PROPOSED CHANGE ORDER REQUEST

Contract Name: Snapfinger Advanced Wastewater Treatment Facilities Date: 4/24/2018
Expansion- Phase 2

Subject: Proposed Change Order #1

Proposed Change Order # 007B
Pipe Encasement per Submittal Comments

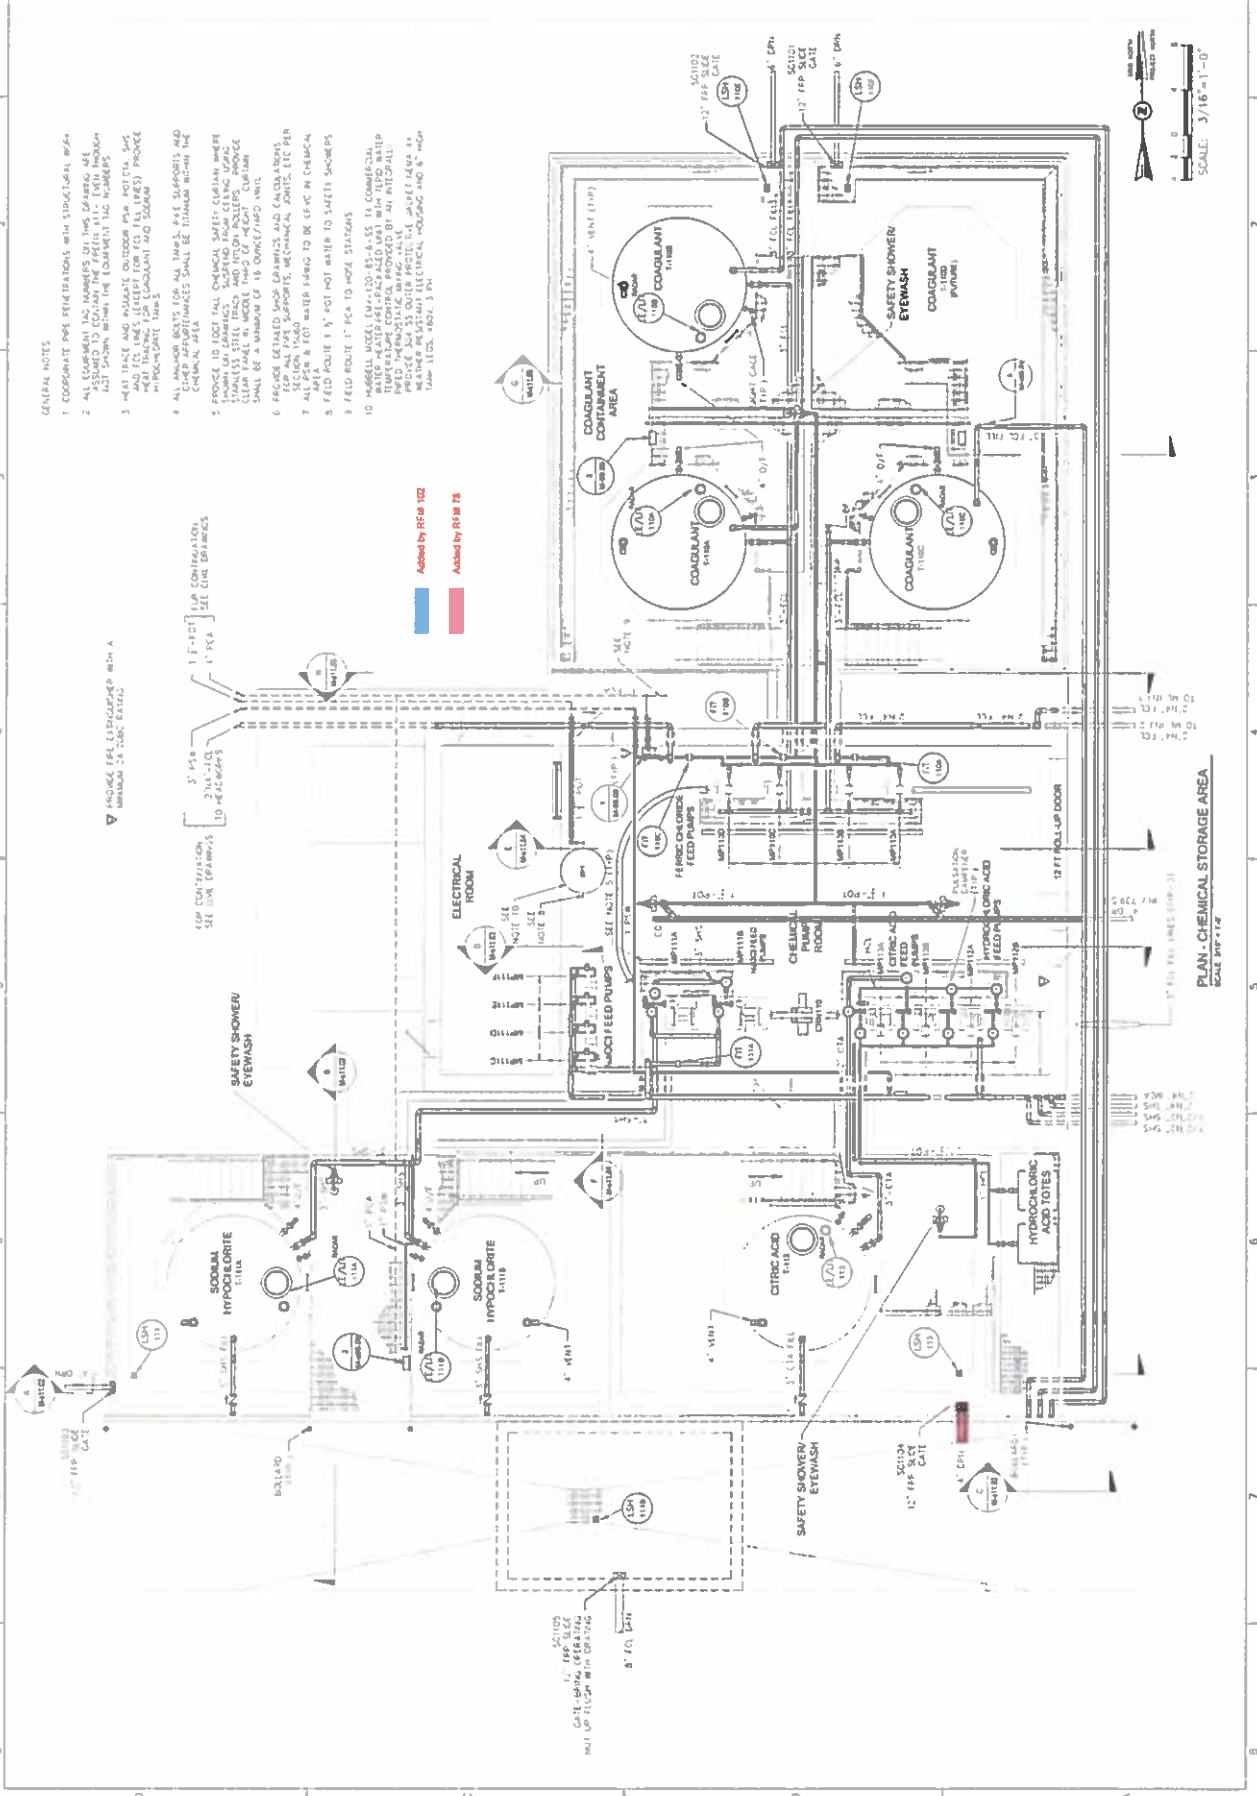
Added by R1P at 102
 Added by R1P at 175
 There is no pop here and therefore does not need concrete encasement
